> Peach Bottom Atomic Power Station, Units 2 and 3 Renewed Facility Operating License Nos. DPR-44 and DPR-56 Docket Nos. 50-277 and 50-278

Subject: License Amendment Request for Adoption of TSTF-478-A, Revision 2, "BWR Technical Specification Changes that Implement the Revised Rule for Combustible Gas Control," Using the Consolidated Line Item Improvement Process

U.S. Nuclear Regulatory Commission License Amendment Request Containment Atmospheric Dilution System Elimination From TS Docket Nos. DPR-44 and DPR-56 July 30, 2009 Page 2

B 3.6-35

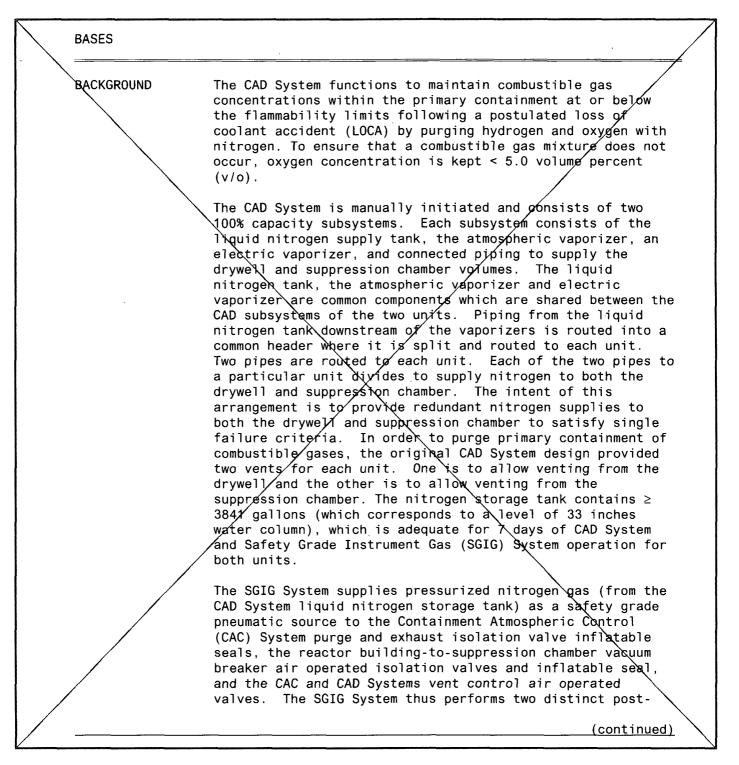
To support SGIG System functions, the CAD System liquid nitrogen storage tank minimum required level is a 16 inches water column and a minimum required SGIG System header pressure of 80 psig. <u>Minimum requirements for the CAD</u> System liquid nitrogen storage tank to support CAD System OPERABILITY are specified in LCO 3.6.3.1, "Containment Atmospheric Dilution (CAD) System."
APPLICABLE SAFETY ANALYSES	Analytical methods and assumptions involving the reactor building-to-suppression chamber vacuum breakers are used as part of the accident response of the containment systems. Internal (suppression-chamber-to-drywell) and external (reactor building-to-suppression chamber) vacuum breakers
SAFETY ANALYSES	part of the accident response of the containment systems. Internal (suppression-chamber-to-drywell) and external

#### B 3.6.3.1 Containment Atmospheric Dilution (CAD) SystemDeleted

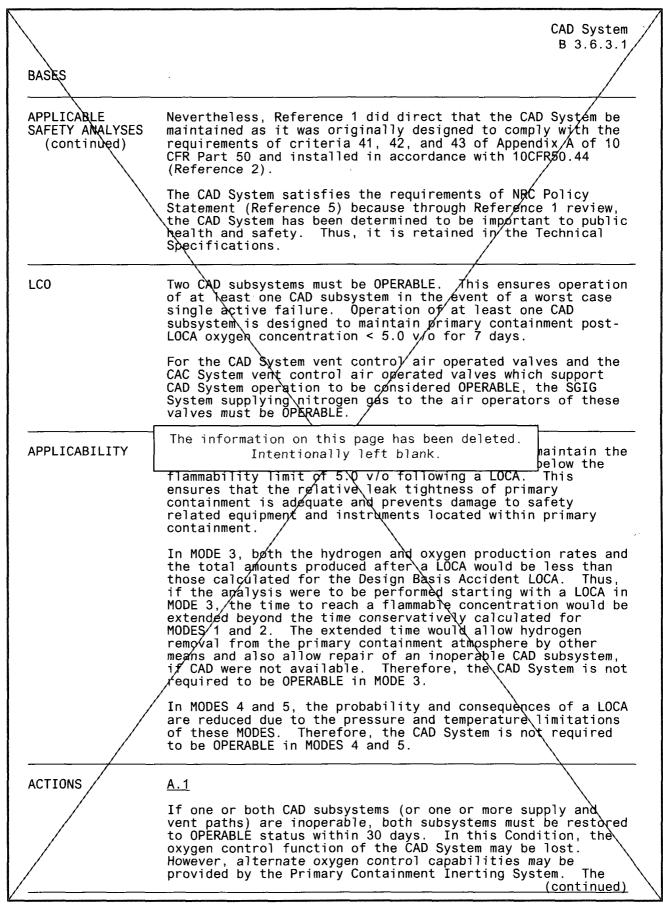
CAD System B 3.6.3.1 BASES BACKGROUND LOCA functions: (1) supports containment isolation and (2) supports CAD System vent operation. SGIG System requirements are addressed for each of the supported system and components in LCO 3.6.1.3, "Primary Containment Isolation Valves (PCIVs)," LCO 3.6.1.5, "Reactor Building-to-Suppression Chamber Vacuum Breakers," and LCO 3.6.3.1, "Containment Atmospheric Dilution (CAD) System." For the SGIG System, liquid nitrogen from the CAD System liquid nitrogen storage tank passes through the CAD System liquid nitrogen vaporizer (continued) tank passes through the CAD System liquid nitrogen vaporizer where it is converted to a gas. The gas then flows into a Unit 2 header and a Unit 3 header separated by two manual globe valves. From each header, the gas then branches to each valve operator or valve seal supplied by the SGIG System. Each branch is separated from the header by a manual globe valve and a check valve. The CAD System operates as directed in the emergency operating procedures to remove combustible gases from primary containment The CAD System is manually initiated from the main control room in the purge mode as directed by the emergency operating APPLICABLE SAFETY ANALYSES procedures (EOPs) if it/is determined that the concentration of combustible gases in primary containment exceeds the action levels specified in the EOPs. The CAD System is used tion rates The information on this page has been deleted. Intentionally left blank. The CAU System was originally designed to dilute containment oxygen by repressurizing primary containment with nitrogen to approximately/50% of the containment design pressure. Above this pressure, containment would be vented to maintain this pressure while CAD continued to supply diluting nitrogen. The original design calculations demonstrated that, with oxygen generation rates specified in Regulatory Guide 1.7, Table 1 (Reference 3), and the CAD system operated per its original design mode (i.e., repressurization), oxygen concentrations would be maintained < 5 v/o and offsite doses would be maintained less than the requirements of 10 CFR50.44. The PBAPS combustible gas control system has since been reevaluated with oxygen generation rates based on experimentally and analytically determined parameters as permitted in Regulatory Guide 1.7, and documented in NEDO-22155 and Reference 1. As a result it was found that the primary containment inerting alone is sufficient to maintain oxygen concentrations < 5 v/o and that CAD system operation would not be required to control combustible gases. Therefore, the CAD system, and in particular containment venting, is no longer considered the primary means of combustible gas control. As a result, no releases or officite doses are anticipated to result from design basis combustible gas control. (continued)

B 3.6-35

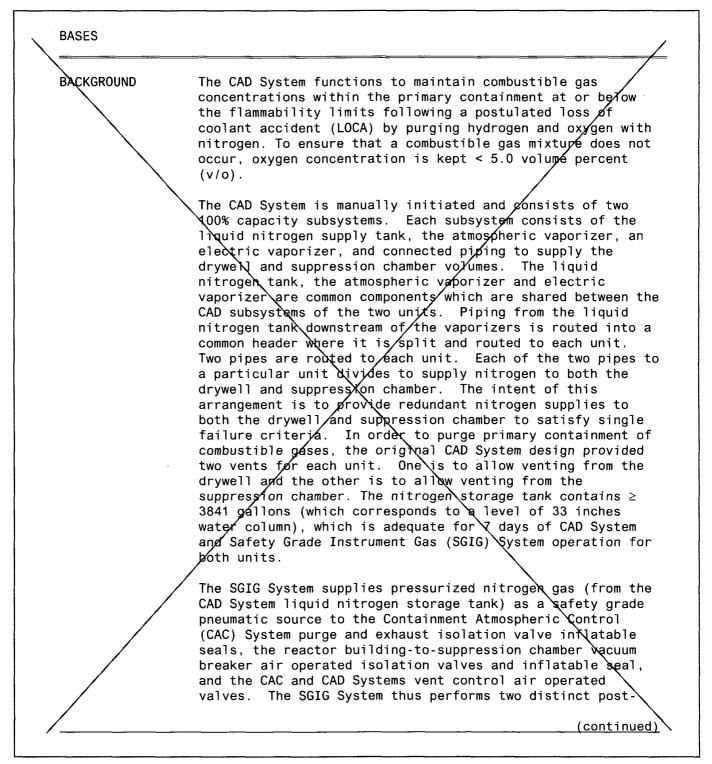
To support SGIG System functions, the CAD System liquid nitrogen storage tank minimum required level is a 16 inches water column and a minimum required SGIG System header pressure of 80 psig. <u>Minimum requirements for the CAD-</u> System liquid nitrogen storage tank to support CAD System OPERABILITY are specified in LCO 3.6.3.1, "Containment Atmospheric Dilution (CAD) System."
APPLICABLE SAFETY ANALYSES	Analytical methods and assumptions involving the reactor building-to-suppression chamber vacuum breakers are used as part of the accident response of the containment systems. Internal (suppression-chamber-to-drywell) and external (reactor building-to-suppression chamber) vacuum breakers
	(continued

#### B 3.6.3.1 Containment Atmospheric Dilution (CAD) SystemDeleted

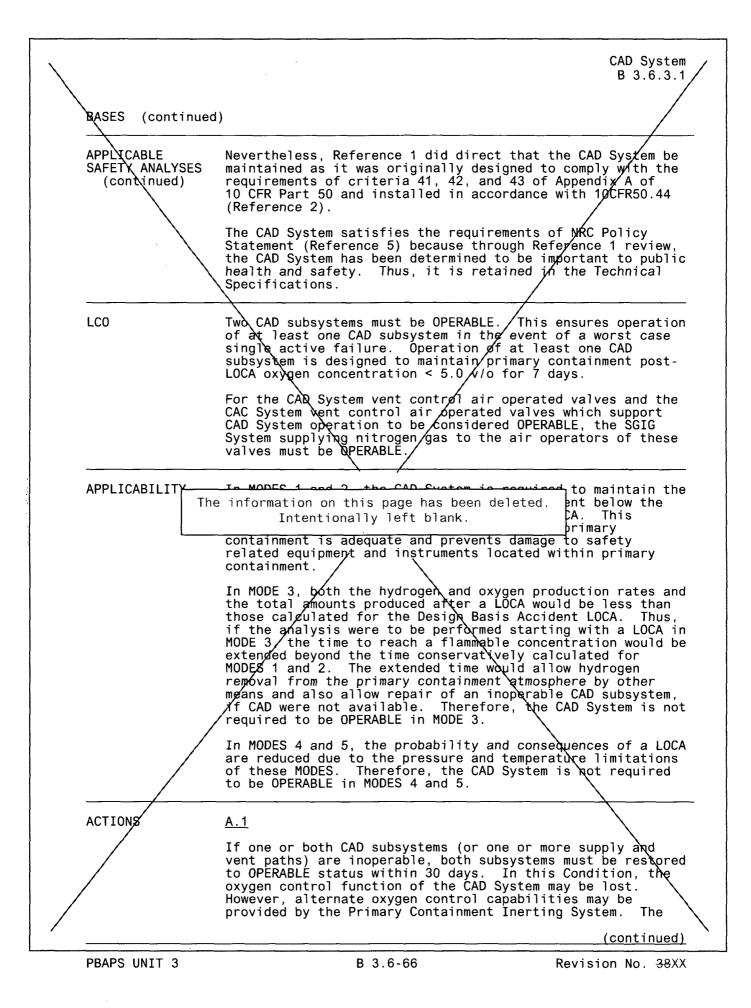
CAD System B 3.6.3.1/ BASES BACKGROUND LOCA functions: (1) supports containment isolation and (2) (cont nued) supports CAD System vent operation. SGIG System requirements are addressed for each of the supported system and components in LCO 3.6.1.3, "Primary Containment Isolation Valves (PCIVs)," LCO 3.6.1.5, "Reactor Building-to-Suppression Chamber Vacuum Breakers," and LCO 3.6.3.1, "Containment Atmospheric Dilution (CAD) System." For the SGIG System, liquid nitrogen from the CAD System liquid nitrogen storage tank passes through the ØAD System liquid Nitrogen vaporizer where it is converted to a gas. The gas then flows into a Unit 2 header and a Unit 3 header separated by two manual globe valves. / From each header, the gas then branches to each valve operator or valve seal supplied by the SGIG System. Each branch is separated from the header by a manual globe valve and a check valve. The CAD System operates as directed in the emergency operating procedures to remove combustible gases from primary containment. The CAD System is manually initiated from the main control APPLICABLE SAFETY ANALYSES room in the purge mode as directed by the emergency operating he concentration The information on this page has been deleted. kceeds the Intentionally left blank. Bystem is used <del>the Lors, and when oxygen gene</del>ration rates exceed the design basis assumptions. The CAD System was originally designed to dilute containment oxygen by repressurizing primary containment with nitrogen to approximately 50% of the containment design pressure. Above approximately 50% of the containment design pressure. Above this pressure, containment would be vented to maintain this pressure while CAD continued to supply diluting nitrogen. The original design calculations demonstrated that, with oxygen generation rates specified in Regulatory Guide 1.7, Table 1 (Reference 3), and the CAD system operated per its original design mode (i.e., repressurization), oxygen concentrations would be maintained < 5 v/o and offsite doses would be maintained less than the requirements of 10 @FR50.44. The PBAPS combustible gas control system has since been reevaluated with oxygen generation rates based on experimentally and analytically determined parameters as permitted in Regulatory Guide 1.7, and documented in NEDO-22155 and Reference 1. As a result it was found that the primary containment inerting alone is sufficient to maintain oxygen concentrations < 5 v/o and that CAD system operation would not be required to control combustible gases. Therefore, the CAD system, and in particular containment venting, is no longer considered the primary means of combustible gas control. As a result, no releases or offisite doses are anticipated to result from design basis combustible gas control. (continued)

<u>A.1</u> (continued) 30 day Completion Time is based on the low pro- the occurrence of a LOCA that would generate his oxygen in amounts capable of exceeding the fla- limit, the amount of time available after the operator action to prevent exceeding this limit availability of other hydrogen mitigating syste <u>B.1</u> If any Required Action cannot be met within the Completion Time, the plant must be brought to which the LCO does not apply. To achieve this plant must be brought to at least MODE 3 within The allowed Completion Time of 12 hours is rea on operating experience, to reach MODE 3 from conditions in an orderly manner and without characteristics	ydrogen and mmability event for t, and the ems. e associated a MODE in status, the n 12 hours. sonable, base full power
the occurrence of a LOCA that would generate h oxygen in amounts capable of exceeding the fla limit, the amount of time available after the operator action to prevent exceeding this limit availability of other hydrogen mitigating syste <u>B.1</u> If any Required Action cannot be met within the Completion Time, the plant must be brought to which the LCO does not apply. To achieve this plant must be brought to at least MODE 3 within The allowed Completion Time of 12 hours is real on operating experience, to reach MODE 3 from	ydrogen and mmability event for t, and the ems. e associated a MODE in status, the n 12 hours. sonable, base full power
